**CERTIFICATE OF APPROPRIATENESS**

**Property:** 527 Frasier Street, Lot 3, Block 7, Freeland Neighborhood Subdivision. The property includes a historic 1,359 square foot, one-story wood frame single-family residence and a detached garage situated on a 5,000 square foot (50' x 100') interior lot.

**Proposal:** Alteration: Front Porch & Windows

**March 16, 2023 (Rear Elevation of Addition) – Inspector’s Photos**

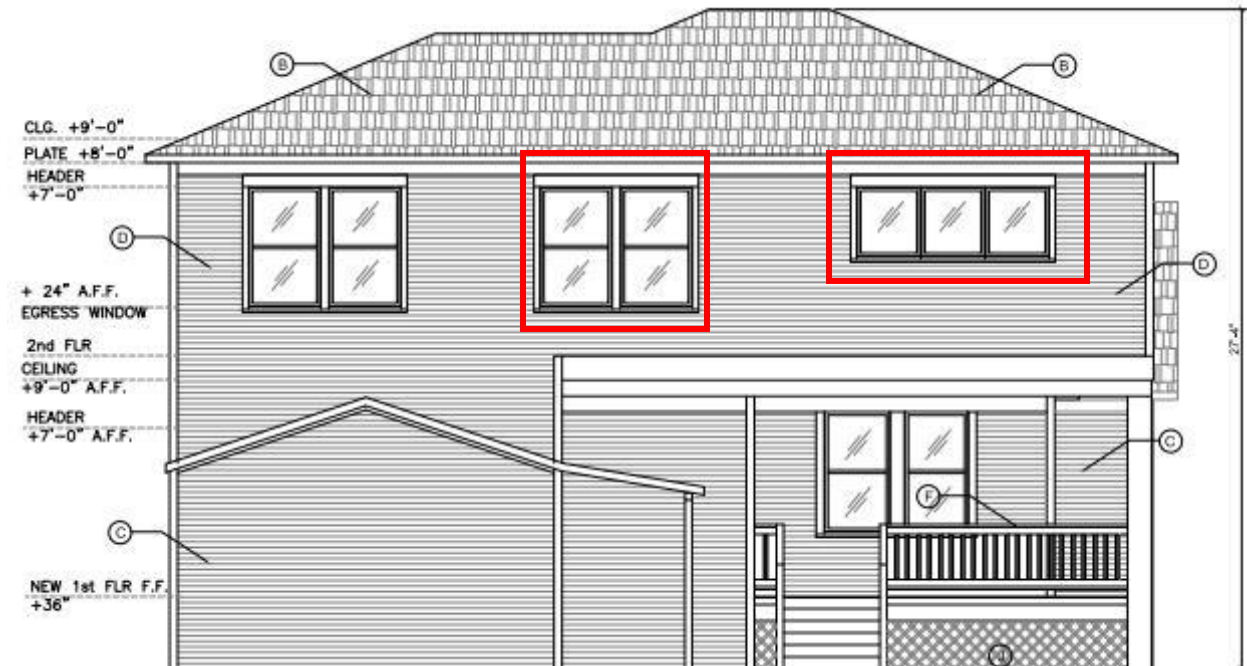
- Site visit by inspector from Houston Permitting Center found vinyl, fin mounted windows installed on rear addition.
  - Staff received email from inspector March 16, 2023

- \*See photos\*
- Staff emailed (3-29-2023) agent and applicant that revised drawings are needed and must return to HAHC for consideration
- Replace already installed vinyl windows with double-hung, 1-over-1, inset & recessed, wood windows

- Replace already installed fixed vinyl windows with fixed, inset & recessed, wood windows
- **Information Subject to Change Before Final Report**

March 22, 2023 (Right Elevation) – Staff’s Photos

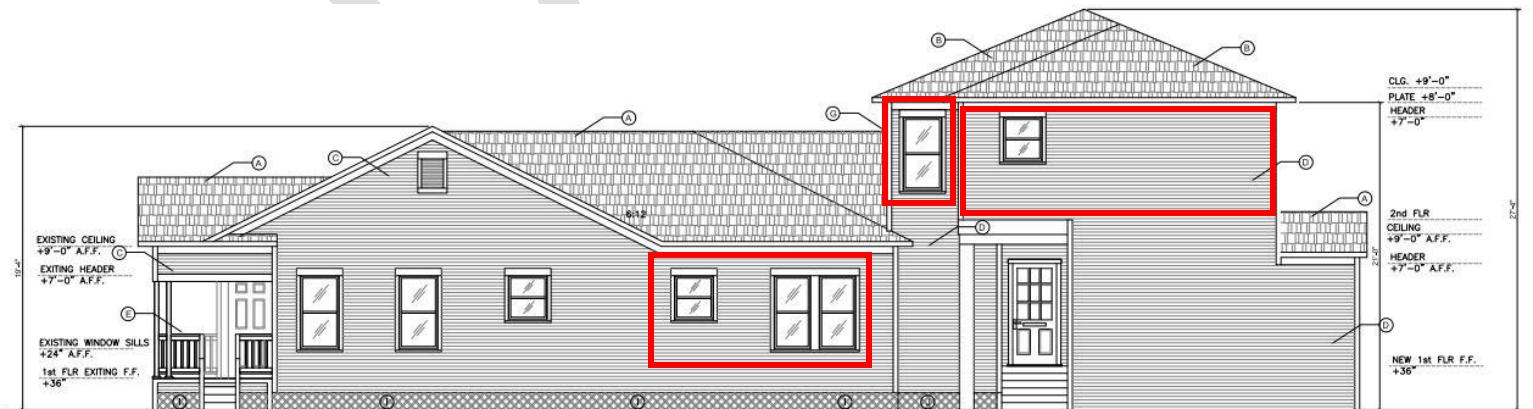
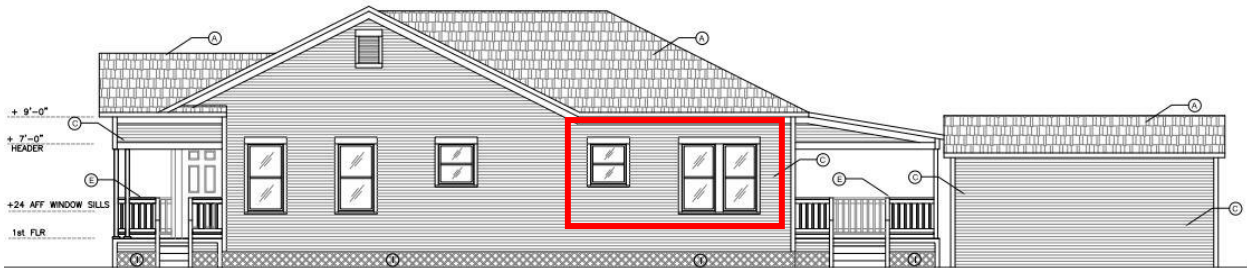
- Staff contacted agent regarding situation
  - Staff conducted site visit on March 22, 2023 to inspect vinyl windows and discovered additional alterations had taken place not in approved COA for fenestrations on rear addition along with alteration to front porch and removal of windows on right elevation of historic structure that were not in the proposed scope of work.

**Recommendation:** **Approval with conditions:**      **Denial of COA. Issuance of COR for work completed and as submitted with the condition that the new window on the right elevation be relocated to the location shown on right side elevation drawing.**
